Group:	SERVICE MANUAL UPDATE
Bulletin No:	SB-16-010
Issue Date:	4-18-2015
Ref. No.	SB-A-11-078

Subject: CORRECTION OF WORKSHOP MANUAL FOR 2008MY-2017MY Correction of the Inspection of the DPR Filter

RELEVANT MODEL: 2008MY-2017MY Hino Trucks

3 INSPECT THE DPR FILTER WITH THE DEDICATED CHECK PROBE.

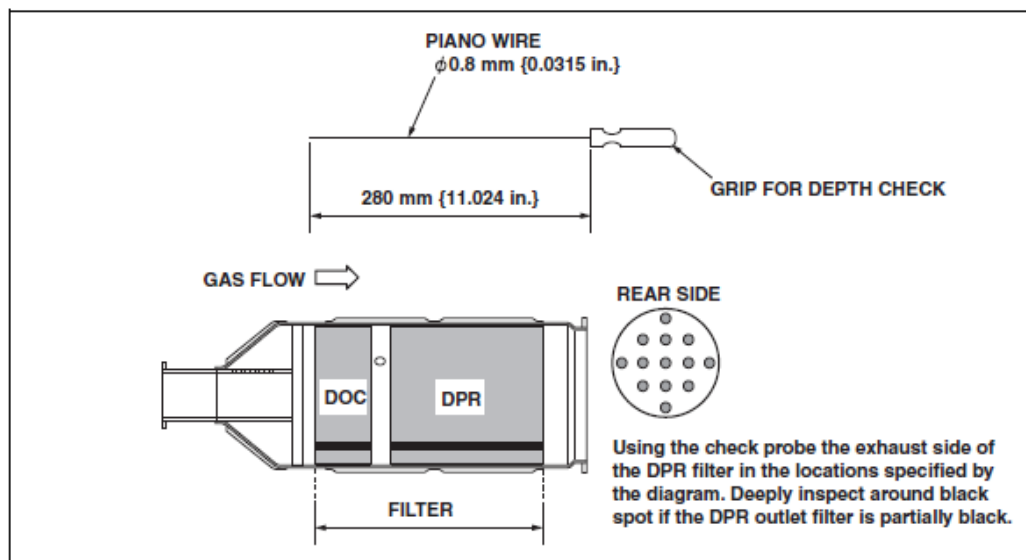
1. Insert the check probe from the rear surface to inspect the inside.

SST: BOSCH part No. HDT650590
FILTER GAUGE ASSEMBLY

- DPR filter internal wall may be damaged if the check probe is significantly bent or skewed. Repair or replace the check probe.
- Do not force the check probe into the DPR filter or push the check probe past the DPR filter length, otherwise DPR filter may be damaged.

CHANGE

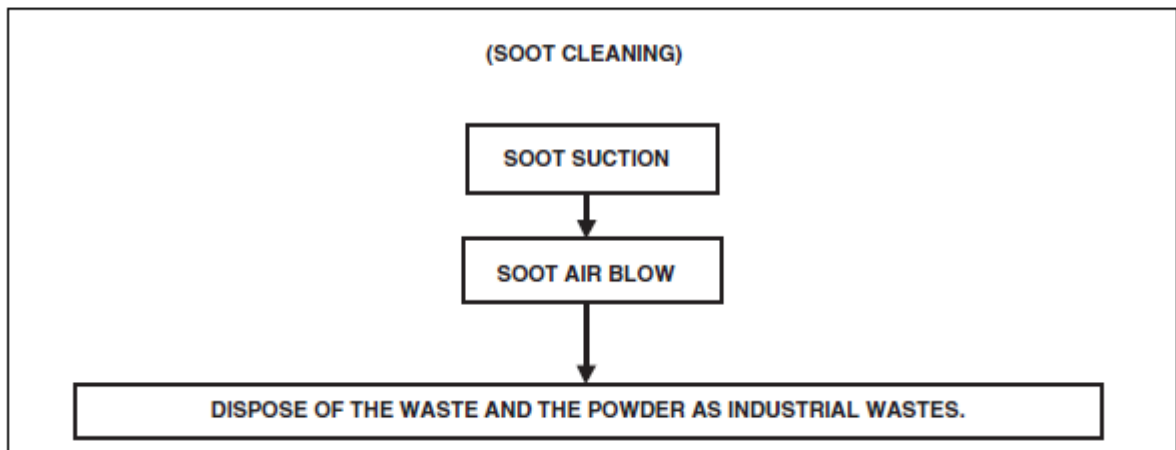
ADD

2. Does the check probe reach the desired depth?

Relevant models	Standard value (Desired depth)
2008-2010MY (HINO 145, 165, 185, 238, 258, 268, 308, 338)	237.5-250.5 {9.351-9.862}
2008-2017MY (HINO 155, 195, 155h, 195h)	
2011-2017MY (HINO 238, 258, 268, 338, 358)	175.9-184.9 {6.926-7.279}

Replace with a new DPR filter and new ^{*}PM sensor, and install them on the vehicle.

CHANGE

DPR filter is normal, clean the tail pipe and then install it on the vehicle.
